MTF Performance Evaluation

Sam Kocsis, Hansel D'Silva Amphenol

November 2025

Related to comments #232, 301, 302

Figure 179A-1—Host-Nominal to Host-Nominal, Cable assembly, and test fixture insertion loss at 53.125 GHz

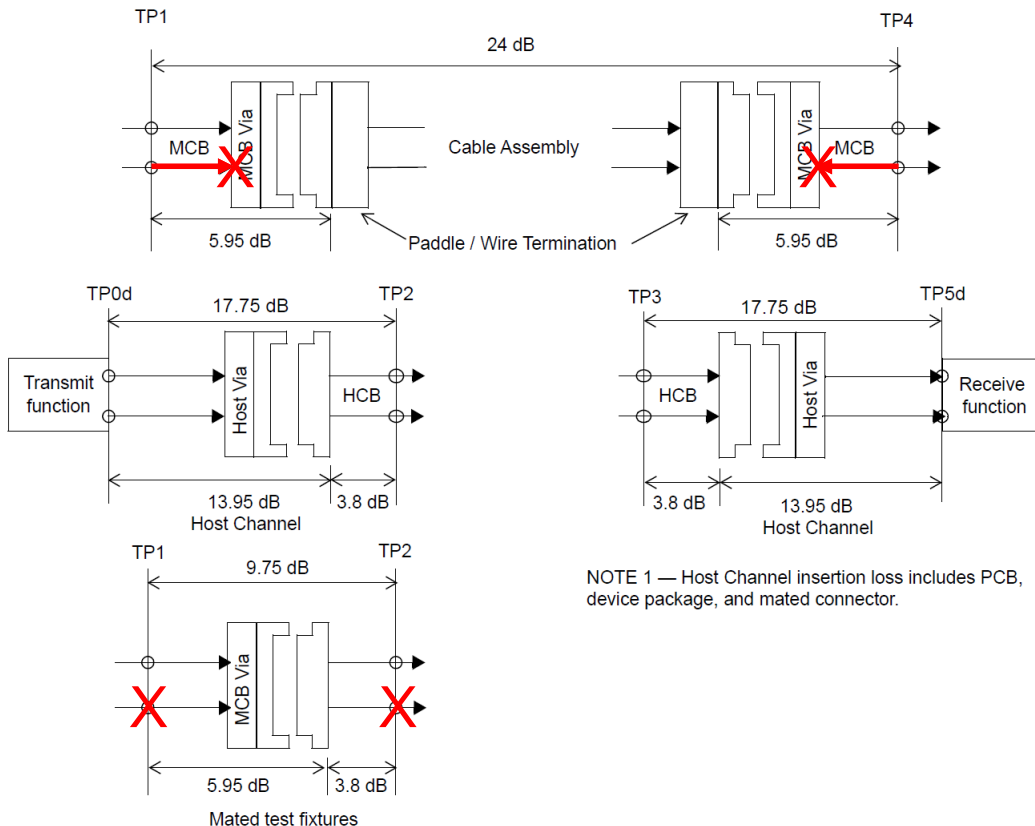
- ERL computations for MTF and CA have different reference points
- Same fixture Pass CA, but Fail MTF

Cabled-based Fixture

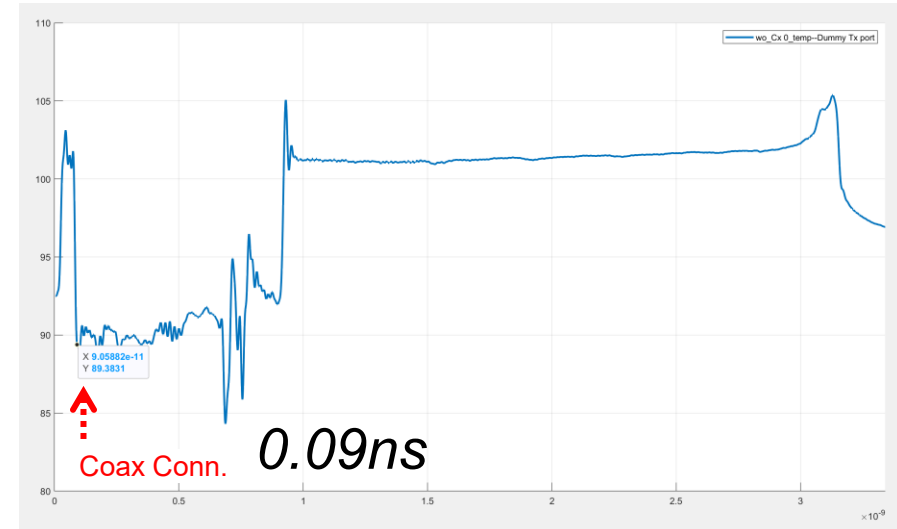
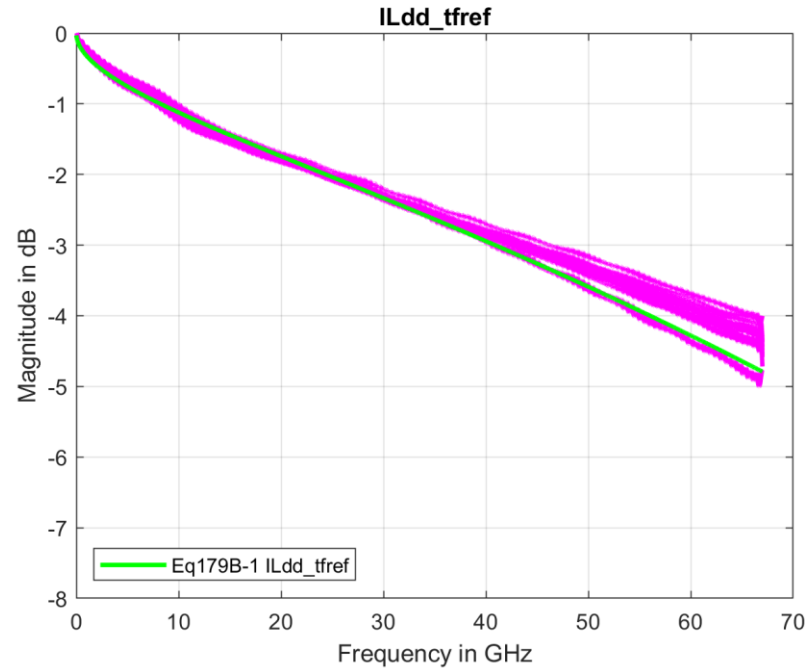
- The issue persists for multiple implementation styles
- A T_{fx} of 0.15ns should fully remove effects of coaxial connector

TP2 or TP3 Fixture “HCB”

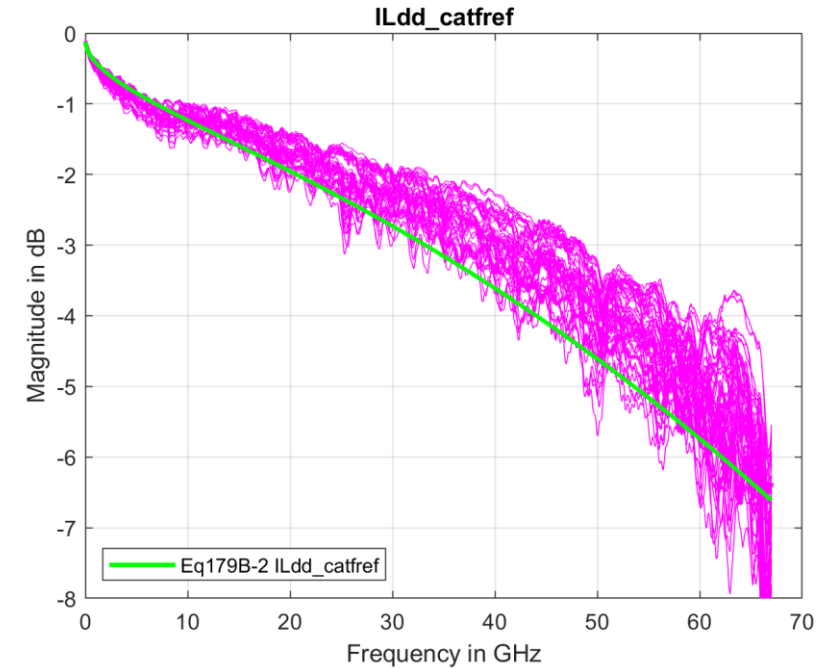
Sample Delta IL = ~0.5dB

Illdd_tfref obtained by open circuit HCB measurement
described in [kocsis 3dj 01 2509](#)

CA Test Fixture “MCB”

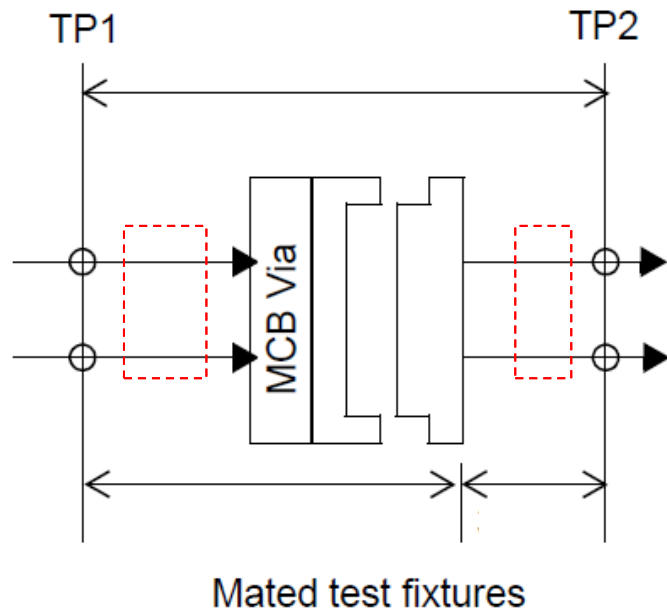
Sample Delta IL = ~1.0dB

Illdd_catfref obtained by MTF-HCB calculation

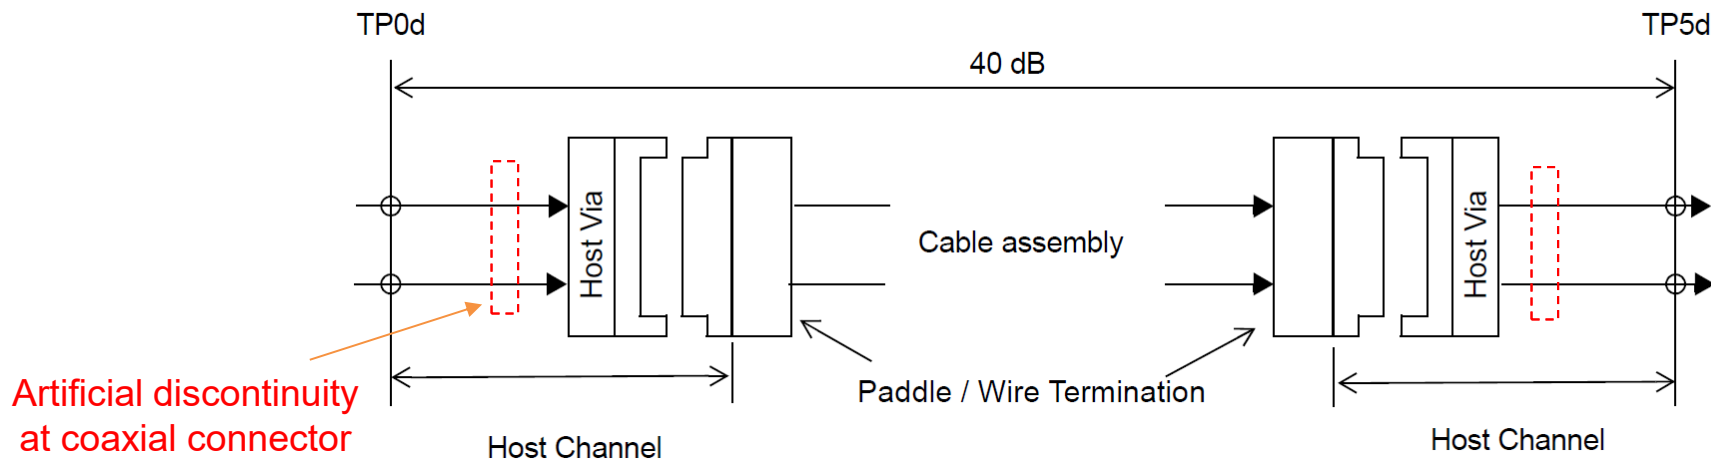
- ERL results typically do not correlate with COM results
- Different ERL reference planes makes interpretation of results difficult
- Propose to allow a T_{fx} of 0.15ns in Table 179B-1 (for MTF)
- Consider interest in enabling de-embedding for future Draft

Figure 179B-4—Mated test fixtures common-mode to common-mode return loss requirements

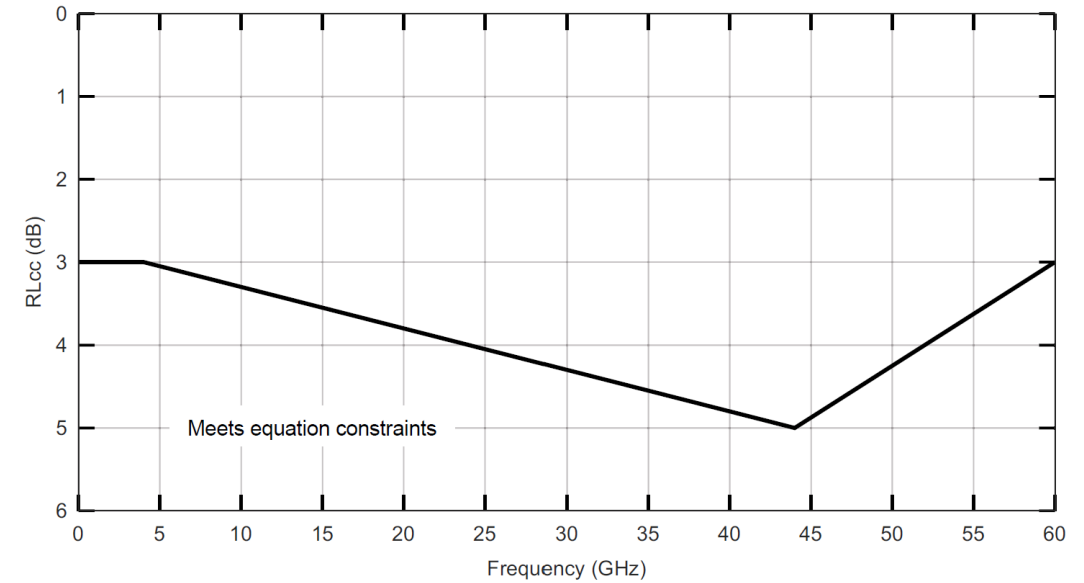
- Issue #1 – This is the only mask in 179B that doesn't extend to 67GHz
- Issue #2 – The mask may be overly constraining for the use cases

Figure 179B-4—Mated test fixtures common-mode to common-mode return loss requirements

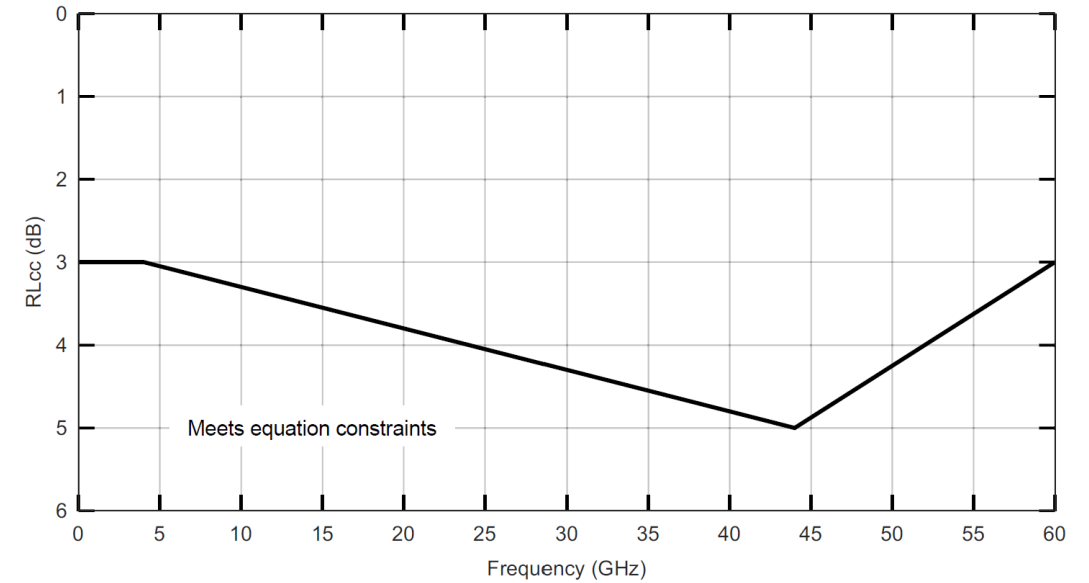
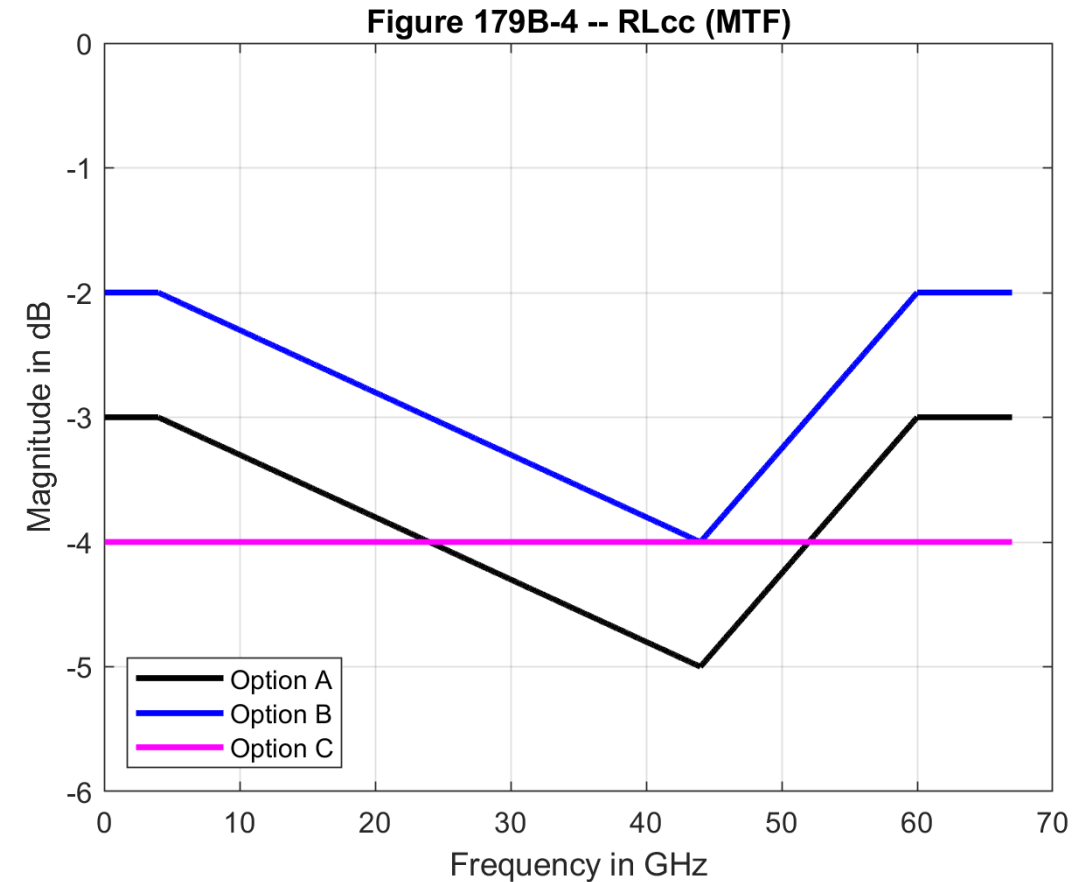
CA Requirement TP1-TP4
C2M Requirement @TP1a/TP4

MTF Requirement TP1-TP2

- Mask needs to be extended to 67GHz
- The observed compliance issue primarily exists on TP1 measurements
- The MCB allocation was reduced by 1dB (assumed with Comment #232)
- Propose to separate RLcc mask for TP1 and TP2 (e.g. Option B/A)
